**US Army Corps
of Engineers®**
New York District

**Integrated Hurricane Sandy
General Reevaluation Report
and
Environmental Impact Statement**

**East Rockaway Inlet to
Rockaway Inlet and Jamaica Bay**

**Appendix G
Public Engagement**

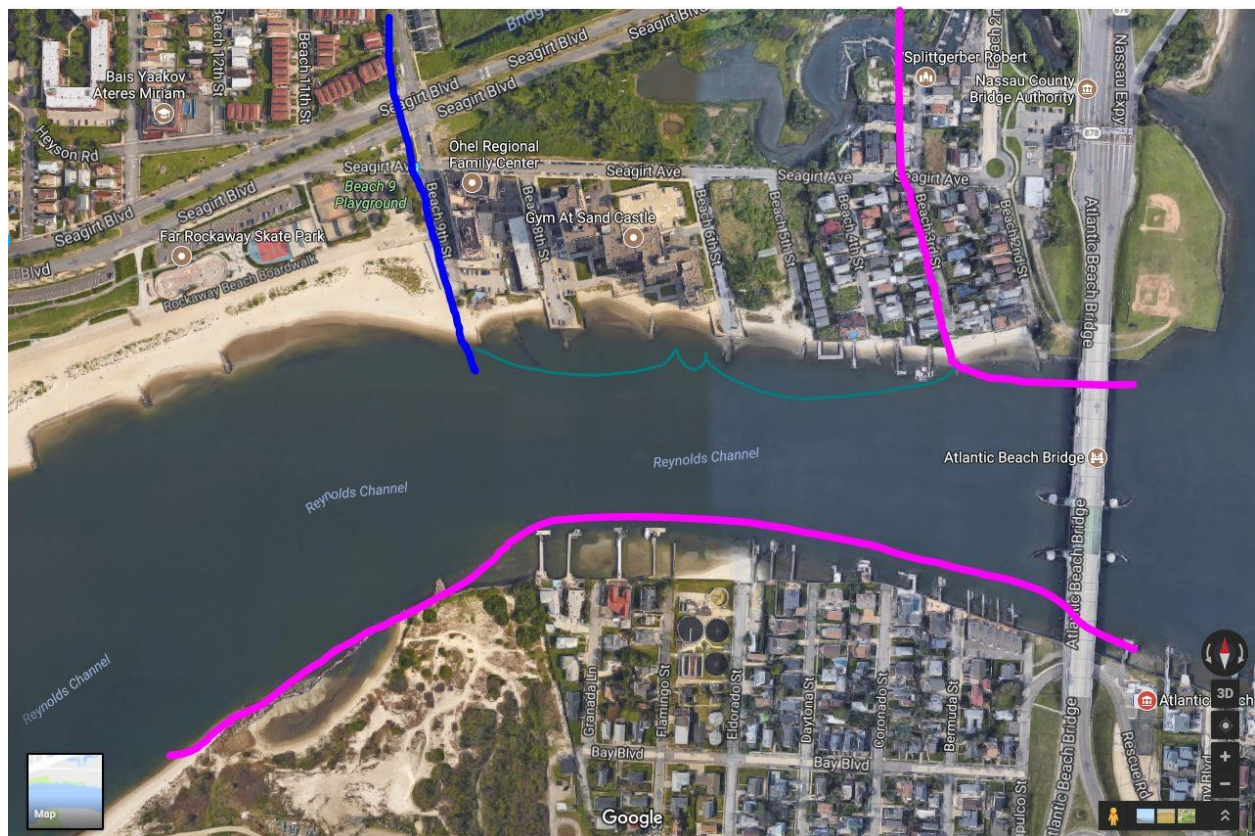
severely restricted. Street lighting along Rte. 878 was ruined and repair began only last week (November 2016). The low-lying residential area north of Seagirt Blvd. was also flooded for up to a half-mile inland. The Report should explore addressing shoreline protection from the proposed tie-in east to Beach 1st Street.

Response: Thank you for this information and description. It is valuable background and will be used to investigate whether federal action is feasible and economically justified under the Nassau County Back Bay Study, which is poised to better address the flood risk experienced by residents in this stretch. The proposed tie-in concept for the eastern end of the Atlantic Shorefront component of the Rockaway Reformulation Recommended Plan ends at Beach 9th Street (the blue line in below figure).
